ADDENDUM TWO

Addendum Two (AD.02) to the drawings and specifications prepared by Gibraltar Design for **Vincennes University – Renovations of the Curtis G. Shake Learning Resources Center** for **Vincennes University**, Vincennes, Indiana.

UNIT "A" ARCHITECTURAL FIRST FLOOR DEMOLITION PLAN

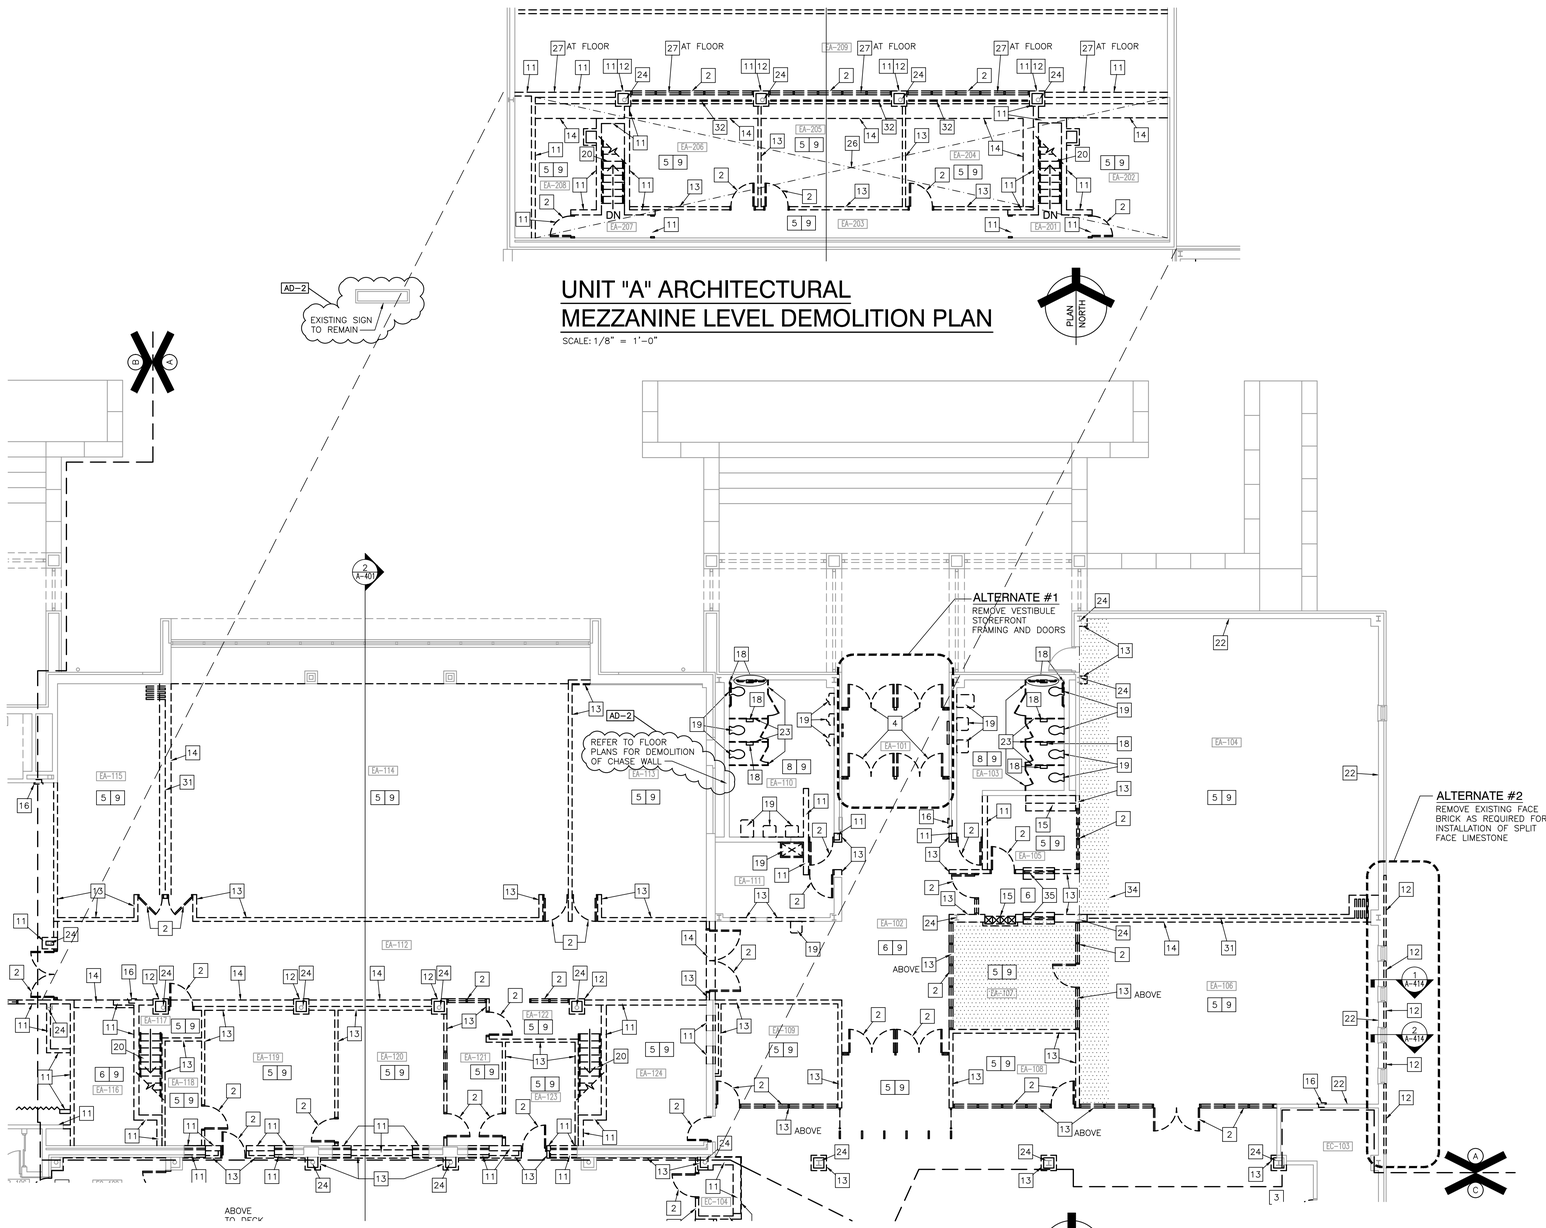
A. Refer to Two (2) revised Full Size Drawing Sheets, included in this Addendum, for added note regarding plumbing chase demolition.

SHEET A-101

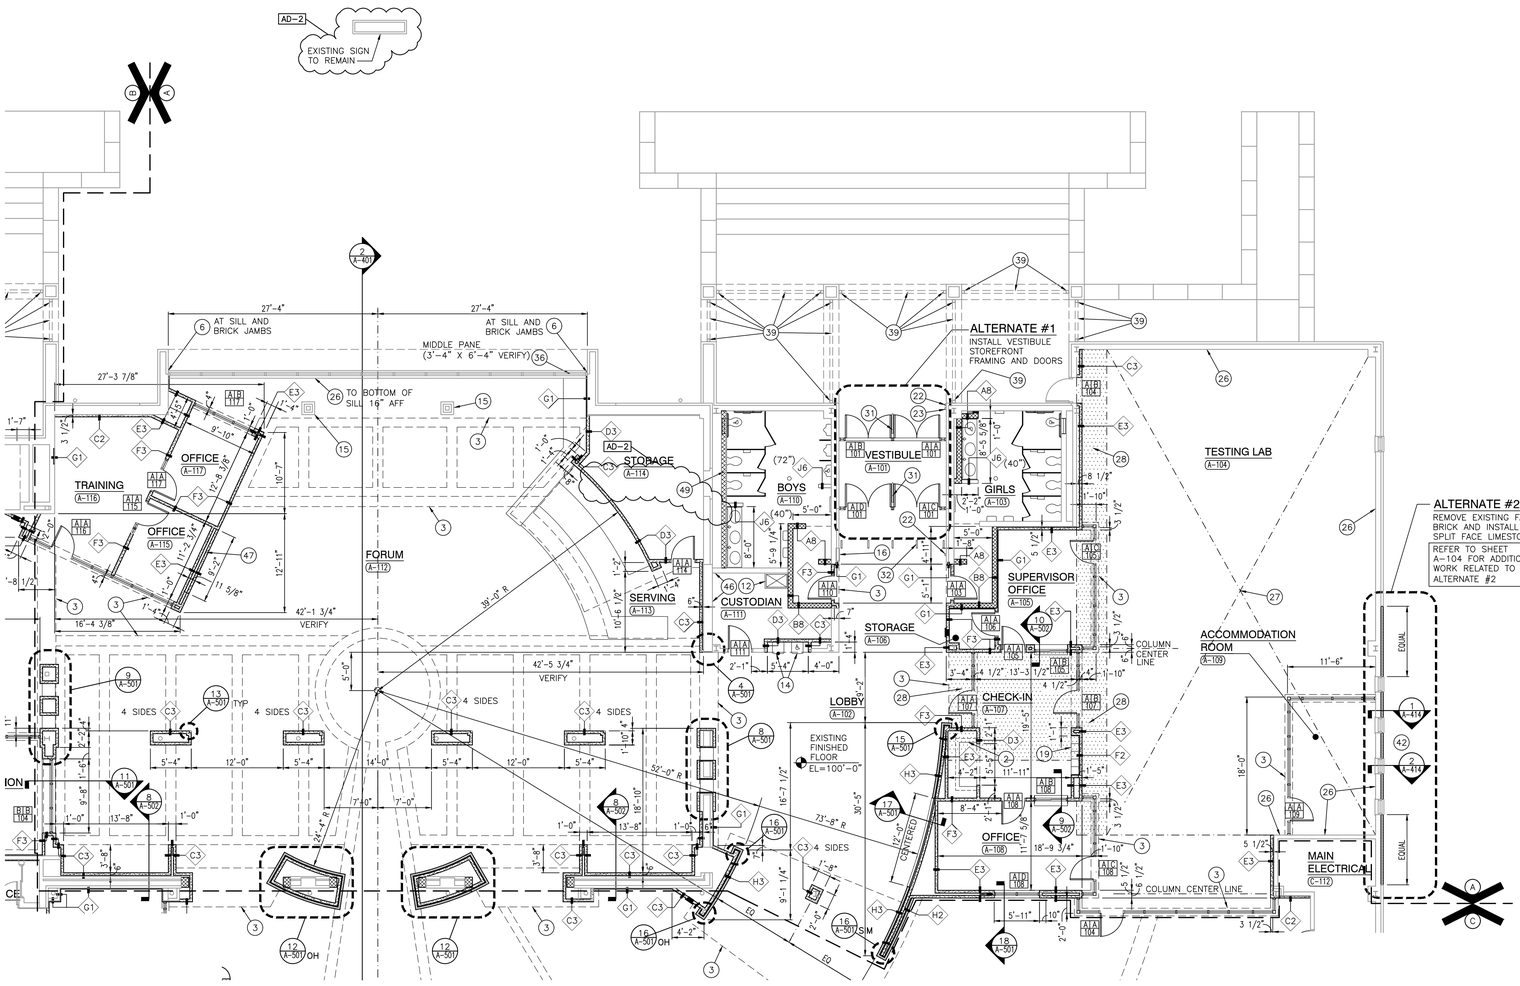
1. Unit "A" Architectural Plan: Add Note 49 regarding the plumbing chase wall.
2. Unit "A" Partial First Floor Plan – Alternate #4: Add exterior storm and sanitary line locations.

UNIT "B" ARCHITECTURAL FIRST FLOOR PLAN

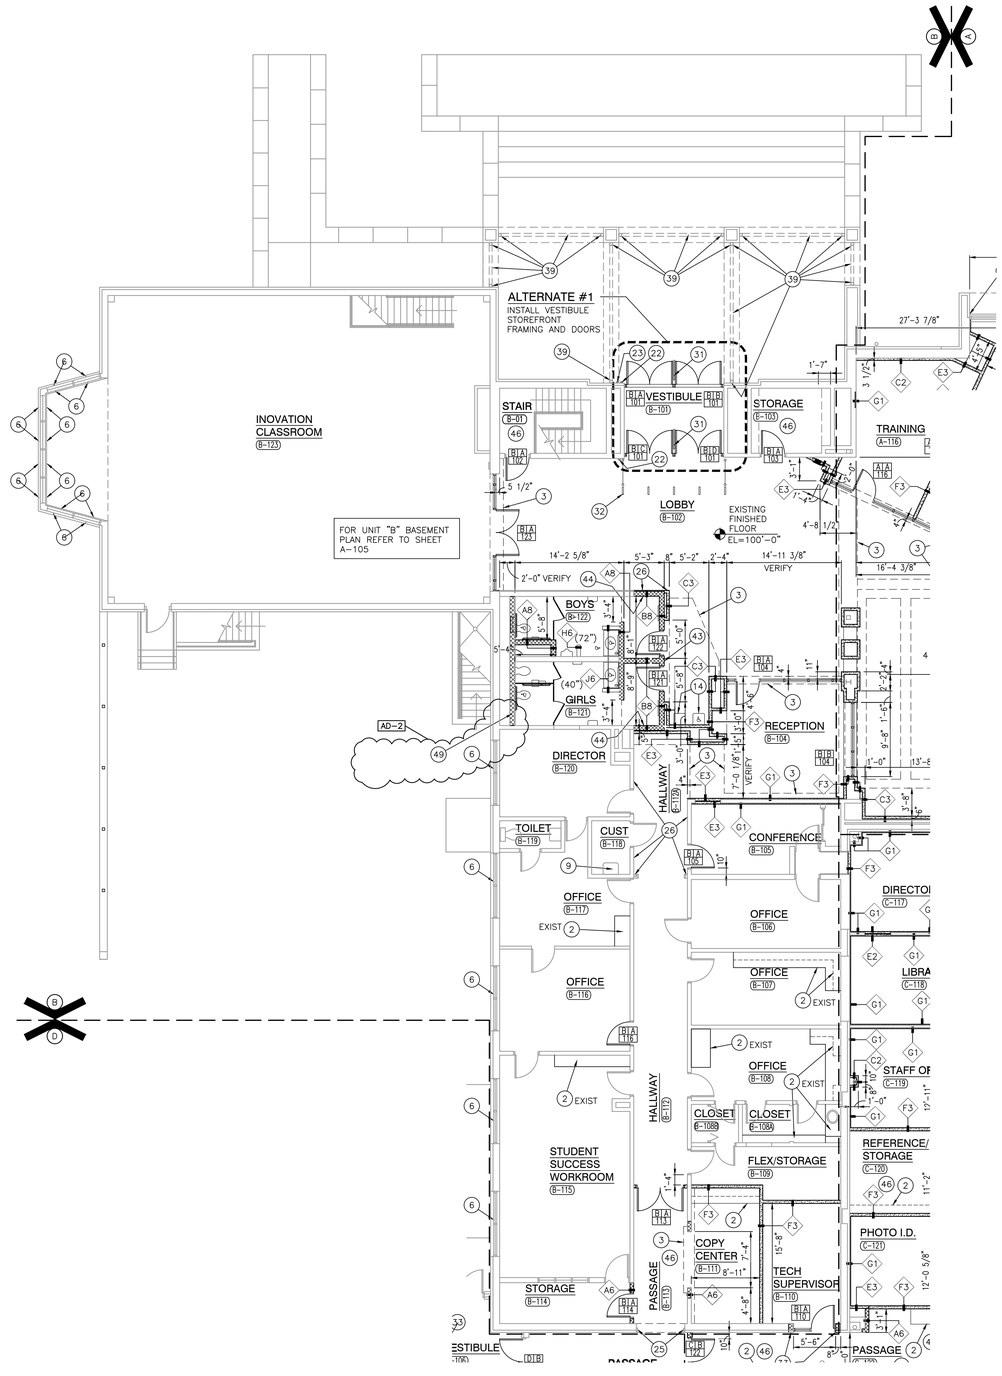
1. Unit "B" Architectural Plan: Add Note 49 regarding the plumbing chase wall.

2 / A–502

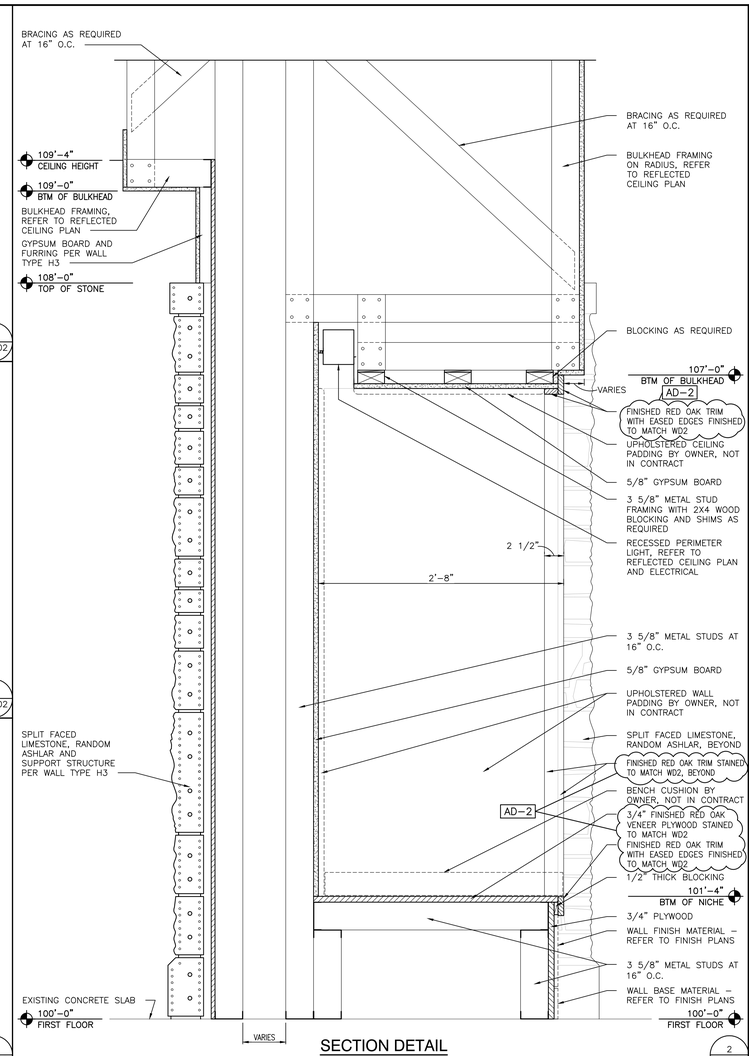
1. Section Detail 2: Revise note referring to wood trim.

1 A-730 ENLARGED PLAN - CIRCULATION DESK
SCALE: 1/4" = 1'-0"

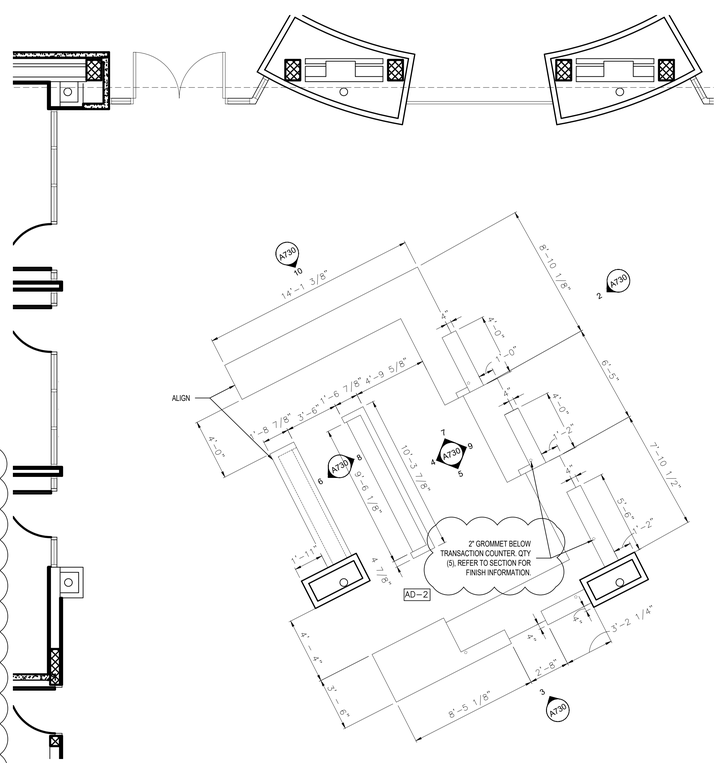
A. Refer to revised Full Size Drawing Sheet, included in this Addendum, for revised Circulation Desk details.
